# MCF5282 Device Errata

Supports: MCF5281 and MCF5282

This document identifies implementation differences between the MCF5282 processor and the description contained in the *MCF5282 ColdFire® Microcontroller User's Manual*. Refer to <http://freescale.com/coldfire> for the latest updates. The errata items listed in this document (summarized in [Table 1](#)) describe differences from the following documents:

Figure 1. Buffer Overrun Example

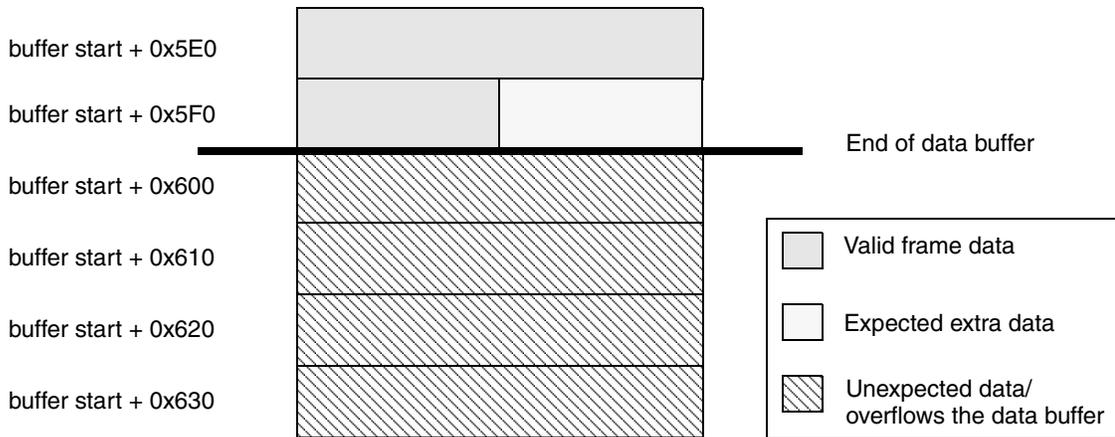
When the FEC is connected to a 10BaseT network, if length of the data stored in a descriptor is not evenly divisible by 16 (not line-aligned), then the FEC will write extra lines at the end of the buffer—the entire line that contains the last valid data is written and at least one extra line, but up to four lines after the end of the valid data can also be written. In most cases this is not a problem, since the extra lines of data still fall within the limits of the buffer. However, if the valid data ends near the end of the buffer, then the extra lines written by the FEC might be outside of the data buffer. This leads to corruption of the next buffer, descriptor, data, or code stored in the adjacent memory.

For example, as shown in [Figure 1](#), if the max buffer size is programmed to 0x600 and a frame that is 0x5F8 bytes long is received, then a line is written starting at buffer start + 0x5F0. The first half of the line at buffer start + 0x5F0 is valid frame data that should be processed by the FEC driver; the second half of the line is additional data that is written because the FEC will only write complete lines. This data should be ignored by the FEC driver. So far, this is correct FEC behavior as originally specified. However, the FEC will repeat the last line of valid data a number of times. The line at buffer start + 0x600 will be written, and as many as three additional lines beyond the end of the data buffer could be written.

1. Only use 100BaseT.
2. Allocate extra lines for the receive data buffers. The actual allocated memory for each buffer should be equal to the receive buffer size programmed in the FEC's EMRBR register plus four lines (16 byte-sized lines).
3. Program the data buffer size one line larger than the max packet size (data buffer size = EMRBR + 0x40).
